## IEEE 802.16.1: Comments for Session #11

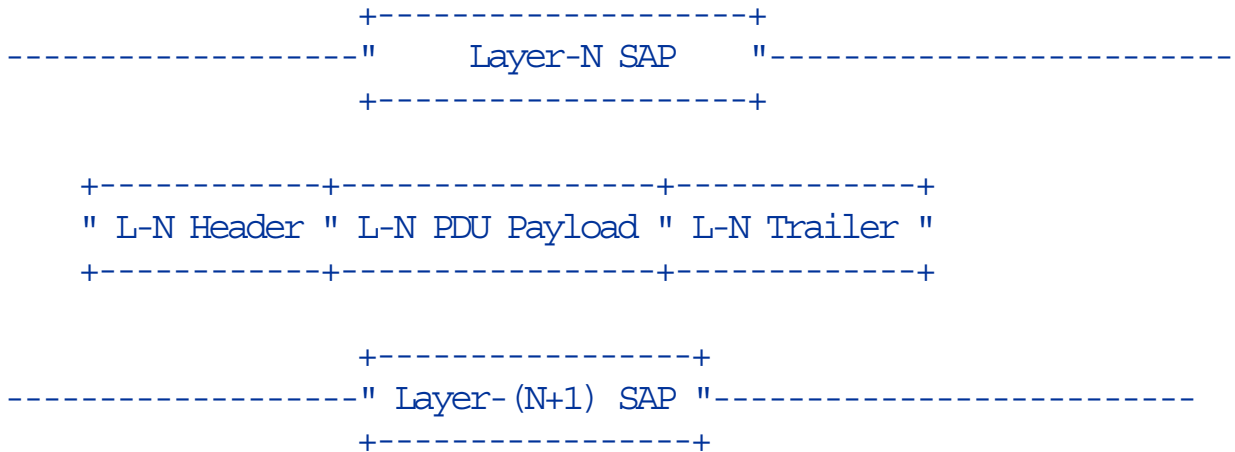
Per ISO /IEC 7498-1:1994, the term "PDU" and "SDU" are clearly defined and should be followed in this draft standard to avoid unnecessary confusion. For example, CS PDU means the data unit generate and handed by the CS layer to the MAC layer.

The following picture shows the architecture of a typical protocol layer and the structure its PDU.

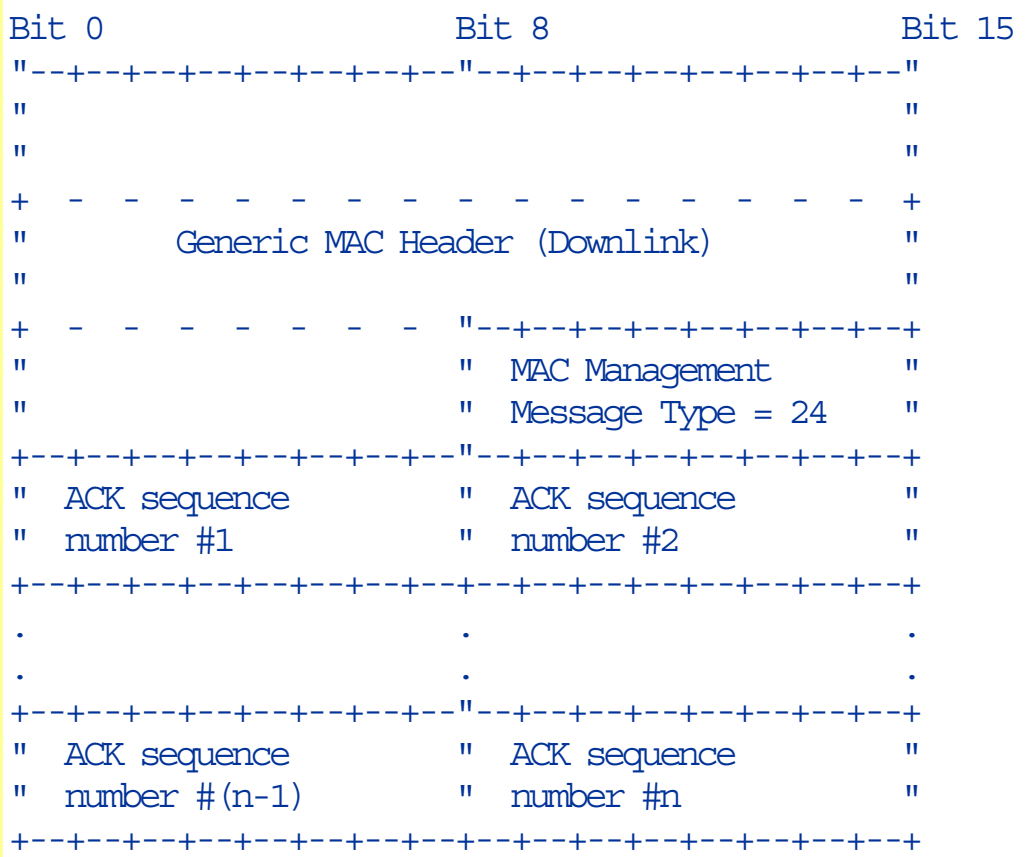
See also document number IEEE 802.16.1c-00/02 (figure 2) for a VISIO drawing of the text drawing above (with the slight difference that the concatenation of the generic downlink MAC header and the byte specifying the management message type are called 'MAC management header').
